City of Alexandria, Virginia

MEMORANDUM

SUBJECT: 3rd CONCEPT REVIEW OF 899 AND 999 NORTH HENRY STREET
BAR CASE # 2022-00175

Figure 4: Building section showing six stories at building perimeter

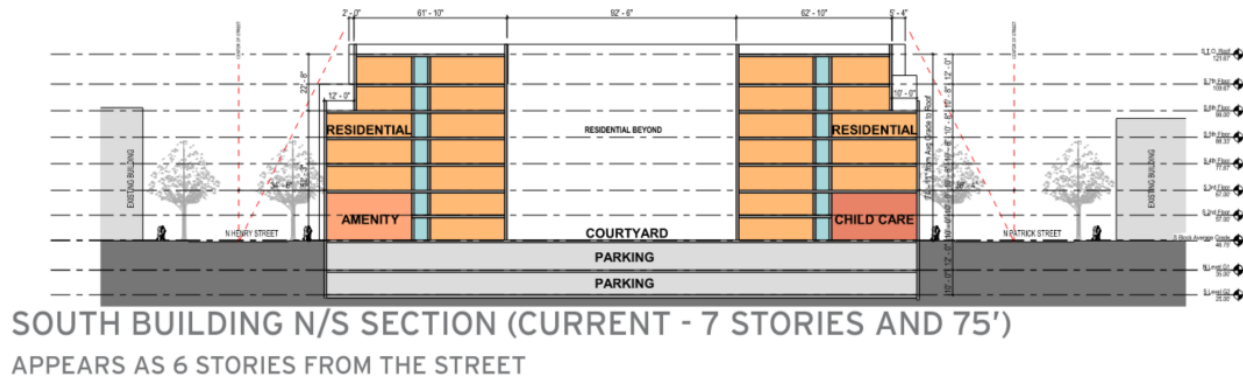
Some members of the Board and members of the public noted that the south building which is adjacent to the historic district is proposed to be seven stories where the north building is proposed to be six stories. In response to these comments, the applicant has modified the design to reduce the overall height of the south building from the previously proposed 83'-0" tall to 75'-0" tall. In addition to this overall lowering of the building, the applicant is proposing a floor configuration that will present the building to the exterior as a six story building instead of a seven story building. The ground floor of the building will include retail, amenity, and childcare uses. These functions require a taller floor to floor height than the typical residential floor. In the portions facing the

In response to comments regarding the overall height of the south building, the applicant has developed a nuanced approach to the vertical stacking of units on the interior and exterior of the building that allows the building to appear to be six stories from the exterior while providing seven stories of residential units. In doing this, the overall height of the building was reduced by 8'-0", making it similar to the height of the northern building. Tall ground floor retail spaces with shorter residential floors above is a typical configuration for mixed use buildings and can be found in historic buildings throughout both districts. Staff finds this to be a clever response to the Board comments, balancing the project requirements with the compatibility of the project to the neighboring structures.

Figure 6: Section showing relation of south building to buildings across Madison Street

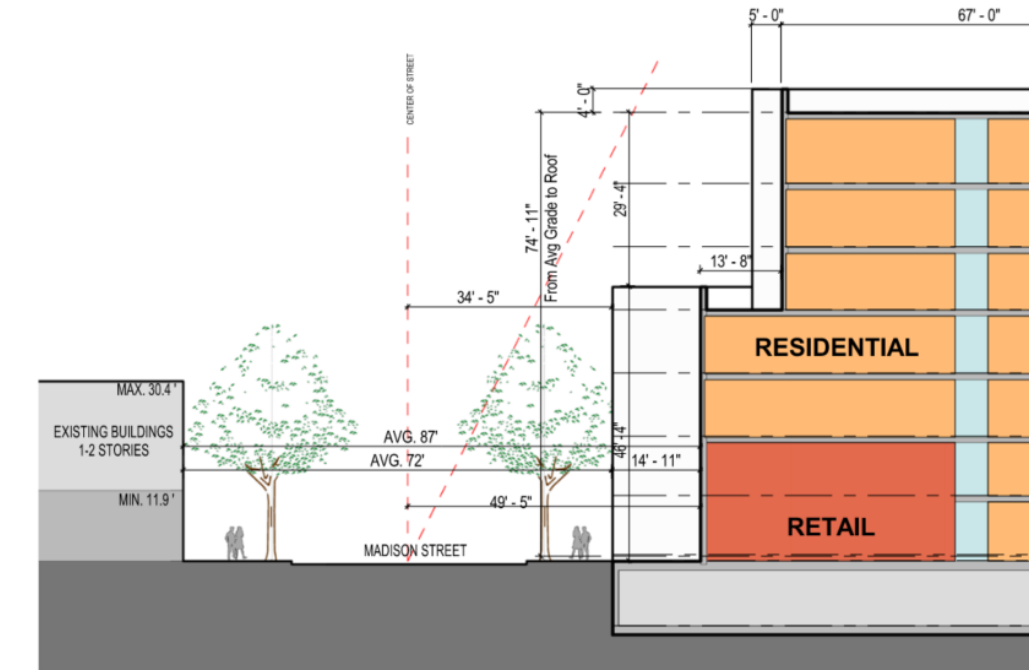
In response to Board comments regarding the relationship between the proposed building and the ones across Madison Street, the applicant has revised the massing at the south end of the south building. An approximately 15'-0" recess has been added to the south elevation to pull the new building as far away from Madison Street as possible. The recessed portion of the new building is an average of 87'-0" from the existing buildings with the portions of the building at the corner an average of 72'-0" from these buildings (Figure 6). The applicant has also added a significant setback for the top three floors across the entire south end of the building, bringing the lower portion of the building closer in scale to the neighboring buildings (Figure 7).

When looking at buildings surrounding the project site, the structures to the south of the site are significantly smaller than those on the west, north, or east. It is important to note that only the eastern section of these buildings falls within the district and that one of the buildings is in excess of three stories. The applicant has addressed concerns about the compatibility of the proposed project with these buildings in two ways. The footprint of the building has been modified to include a 15'-0" deep recess for the middle third of the southern elevation. This pushes the majority of the building further away from the smaller buildings, at an average of 87'-0". The applicant is also creating a significant setback at the third floor along the length of the south elevation. This setback ranges in depth from 13'-8" at the recessed portion of the building to 28'-8" at the projecting portions. Far from being a token setback, this effectively places a three story building across the street from the existing buildings across Madison Street from the project site.

Figure 8: Variation in massing height and depth

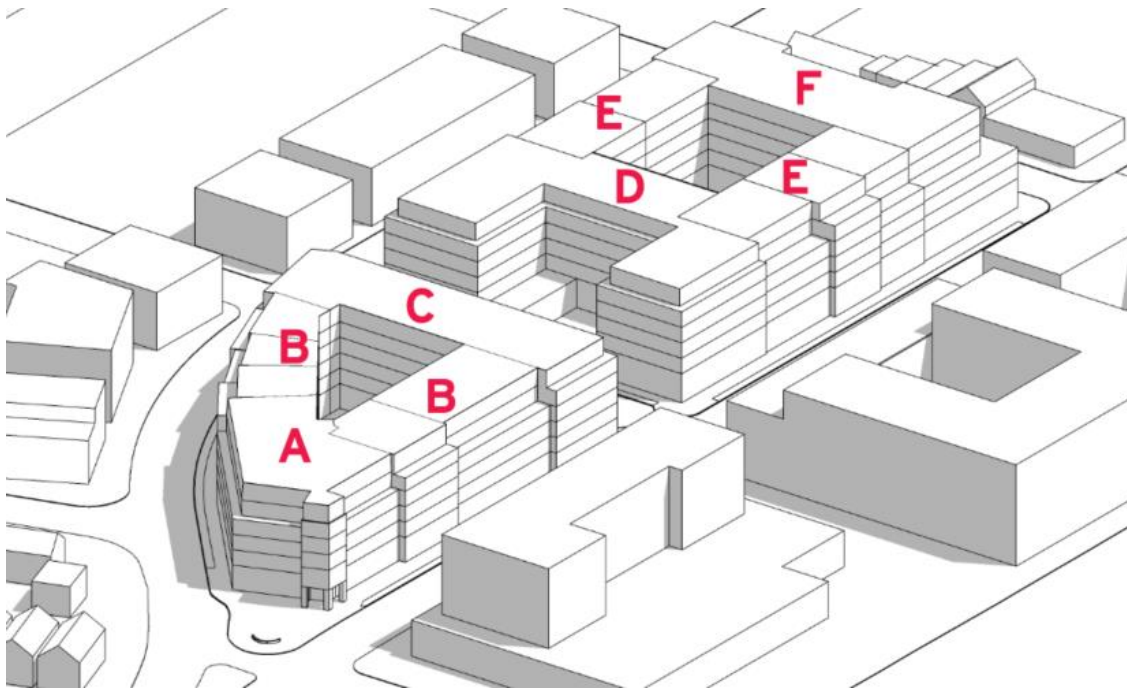
At the last hearing, Board members expressed concern regarding the homogeneous height of building shoulders and the setbacks for upper levels, stating that this consistent height contributes to a feeling that the building is too large for its surrounding. The applicant has addressed this comment by identifying specific locations on the building that respond to adjacent buildings or viewsheds and varying the massing in these locations. As shown in the submitted documents, the proposed design includes a rhythm of massing types with a variety of height and depths for the upper level setback areas. This rhythm breaks up the overall massing, including the roofline, to approximate a rhythm found elsewhere in the historic district (Figure 8).

The variation in the massing breaks up the overall building massing. Staff is supportive of this approach to breaking up the building massing and creating a building rhythm that is similar to those found on blockfaces throughout the district. Corresponding these variations with important intersections or other alignments in the surrounding neighborhood further helps to knit the design into the surrounding fabric. As shown in the massing studies, the variations in height and depth of these bays appears to be significant enough to have a meaningful effect on the perception of the overall building.

OVERALL HEIGHT OF THE SOUTH BUILDING

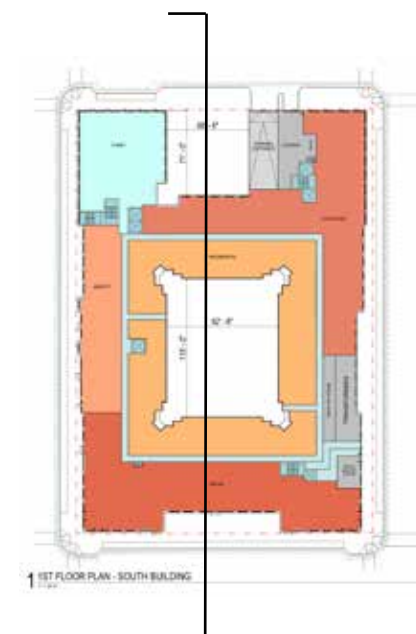
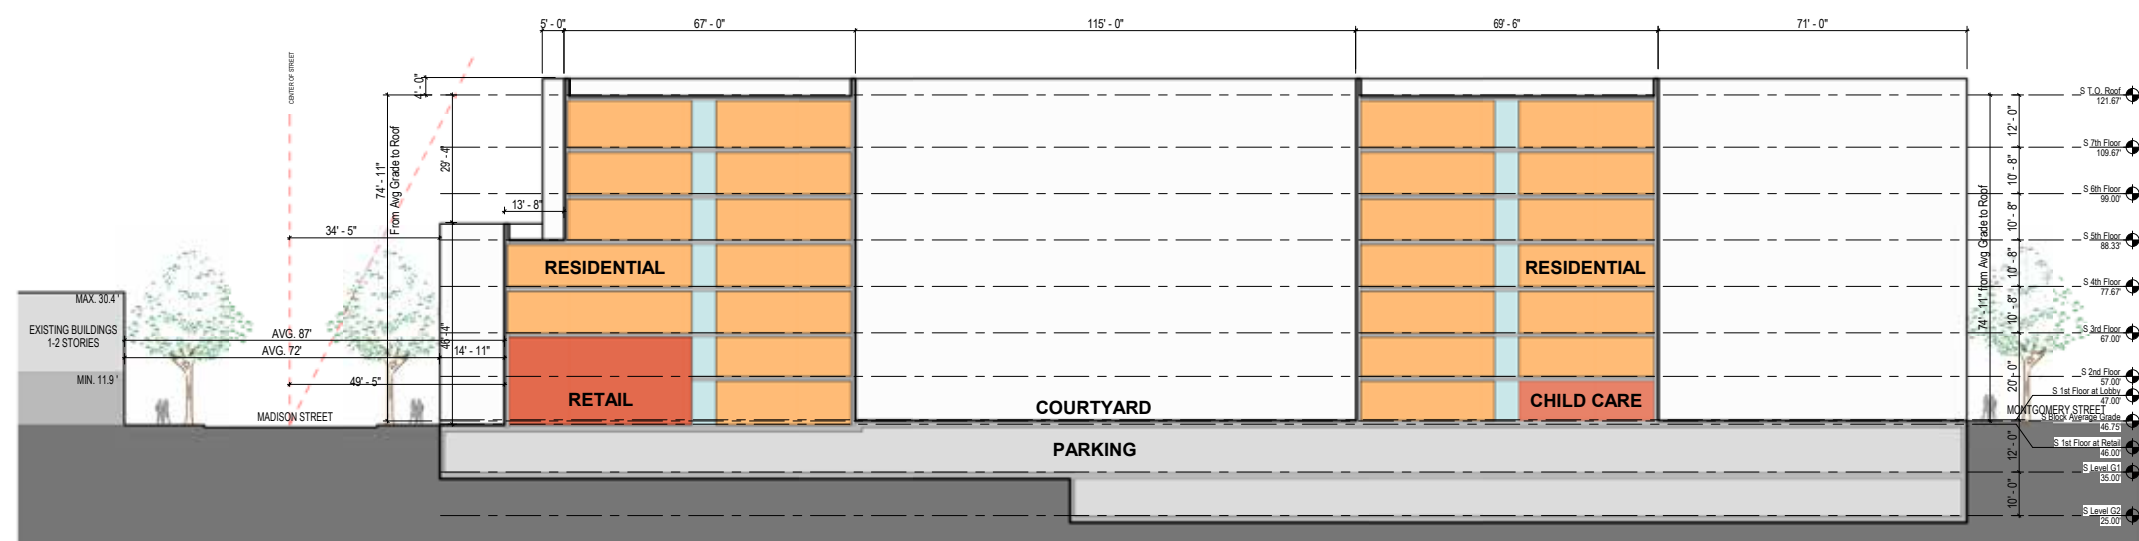
1. STUDY RELATIONSHIP OF SOUTH BUILDING ON MADISON TO EXISTING CONTEXT
2. LOOK AT OVERALL HEIGHT OF THE SOUTH BUILDING
3. CREATE SUN STUDY TO SHOW ANY IMPACT TO ADJACENT BUILDINGS
4. PROVIDE VARIATION OF THE MASSING TO BREAK UP SCALE
5. CONSIDER ARCHITECTURAL CHARACTER ACROSS BOTH BLOCKS
6. DEVELOP MASSING AT NORTH END FOR GATEWAY MOMENT
